TRANS/WP.30/AC.2/2000/13
TRANS/WP.30/2000/19
4 August 2000

**CUSTOMS CONVENTION ON THE INTERNATIONAL TRANSPORT OF GOODS
UNDER COVER OF TIR CARNETS (TIR CONVENTION 1975)**

Validity of vehicles and containers with sliding sheets

Note by the UN/ECE secretariat

Sketch No. 10

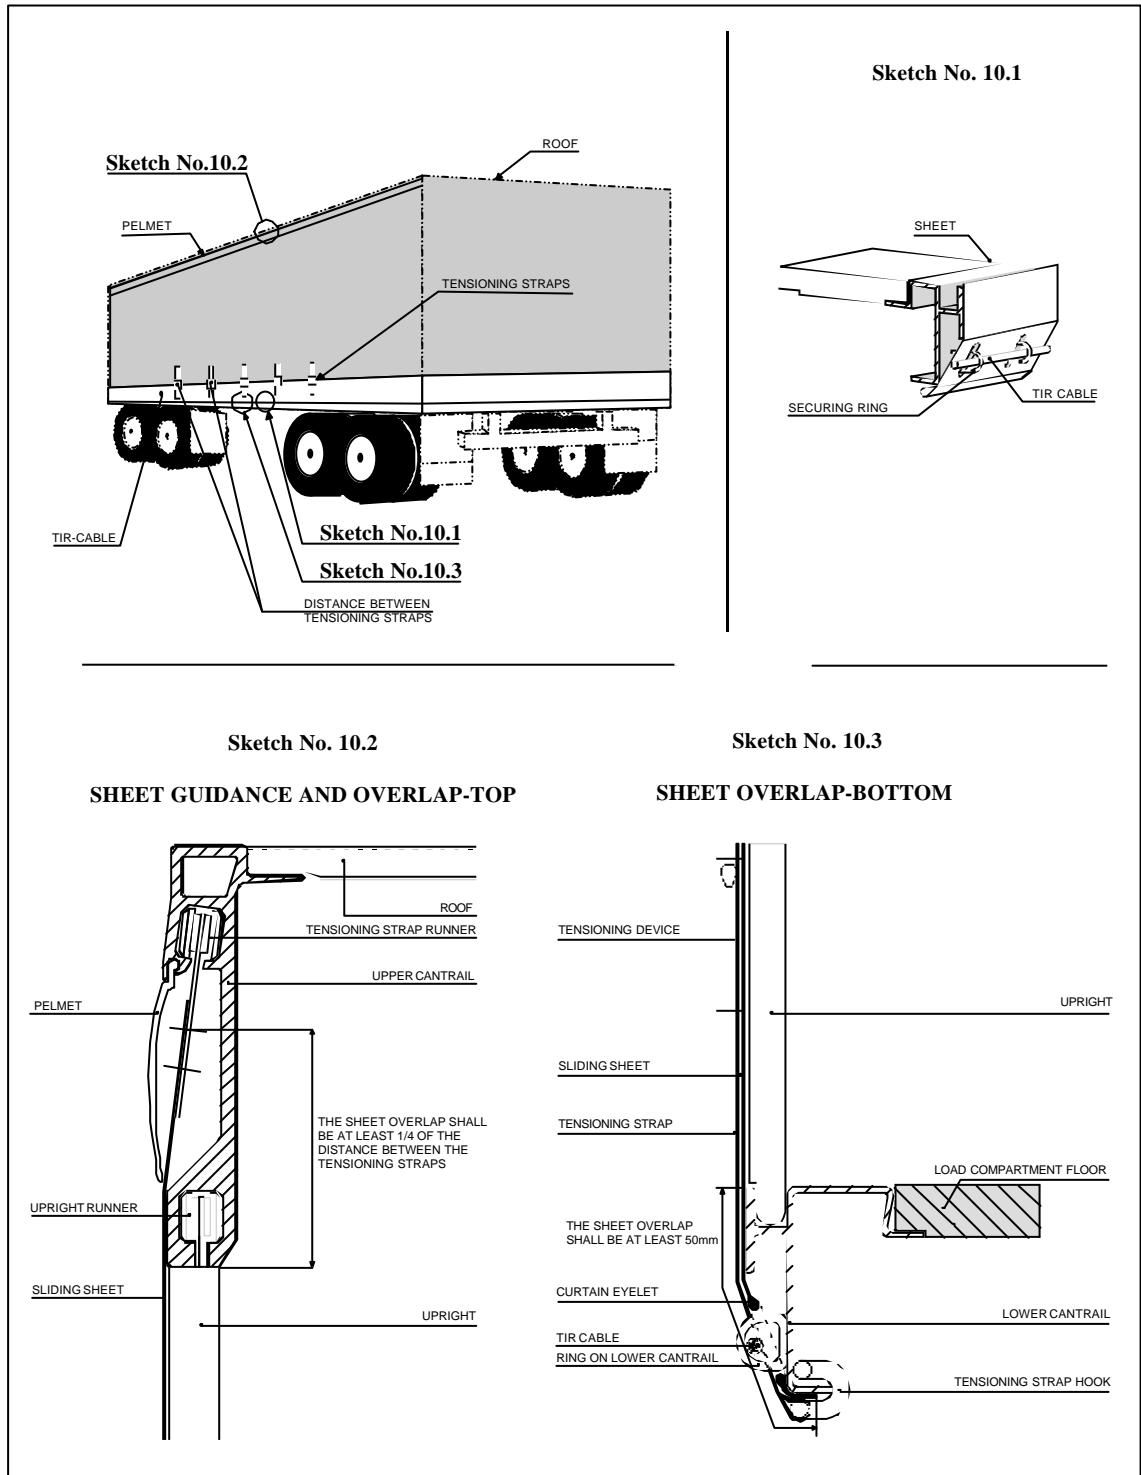
- (iii) The sliding sheet guidance and other movable parts shall be assembled in such a way that closed and Customs sealed doors and other movable parts cannot be opened or closed from the outside without leaving obvious traces. The sliding sheet guidance and other movable parts shall be assembled in such a way that it is impossible to gain access to the load compartment without leaving obvious traces. The system is described in sketch No. 10 appended to these Regulations.

Add the following new sketch to the existing sketches appended to Annex 2:

Sketch No. 10

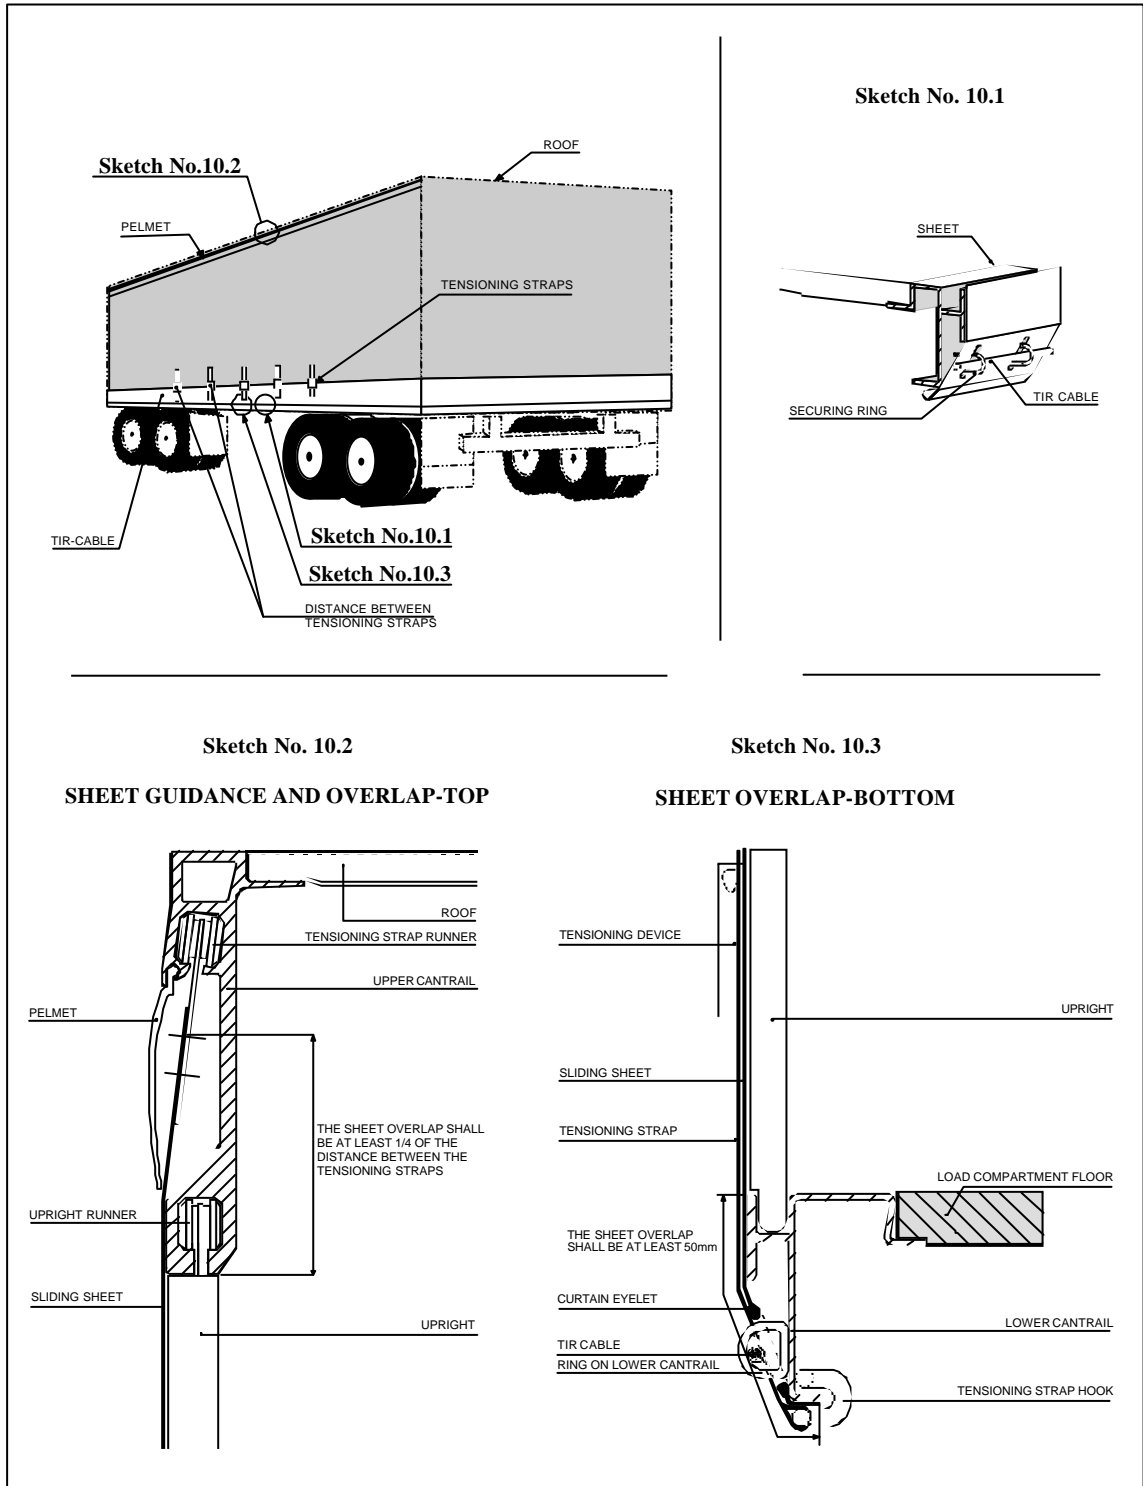
- (iii) The sliding sheet guidance and other movable parts shall be assembled in such a way that closed and Customs sealed doors and other movable parts cannot be opened or closed from the outside without leaving obvious traces. The sliding sheet guidance and other movable parts shall be assembled in such a way that it is impossible to gain access to the container without leaving obvious traces. The system is described in sketch No. 10 appended to these Regulations.

Add the following new sketch to the existing sketches appended to Annex 7:
